Model Evaluation Overview

Groundwater Modeling Group Working Group (GMMWG) Meeting

Summary of EPA/DOH Review of GWFMR and Files

Modeling and Decision Support

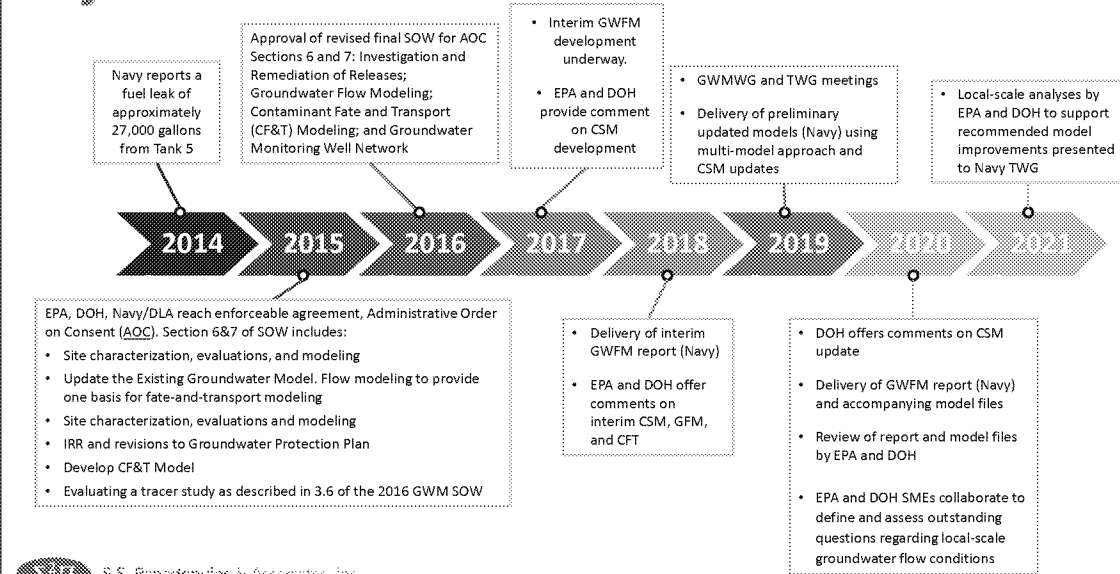
- It is important to understand that the GWFM's cannot alone address fuel (product) migration and mitigation:
 - Mitigation and risk will be driven by fuel release conditions
 - Simplified representation of RH ridge and steady-state approach limit utility
 - Hydraulic containment is not the only potential mitigation strategy
- To reliably evaluate strategies a linkage to fuel transport is needed

Example: Model Layering

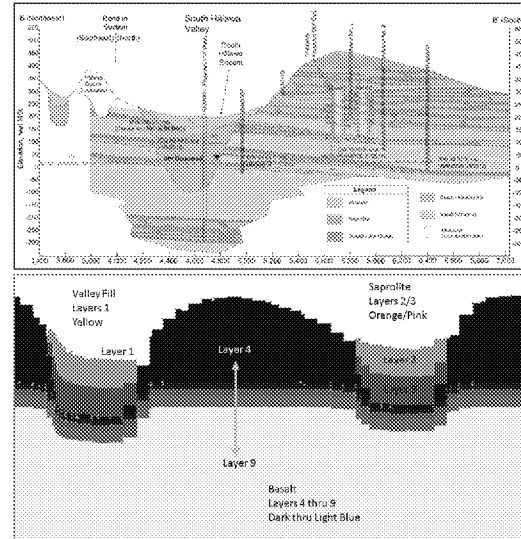
- Use of topographic and structure-following layer approach may have some unintended consequences for transport pathways.
- Evaluate alternate methods to represent transitions between Hydro-stratigraphic units (HSUs) and role of saprolite.
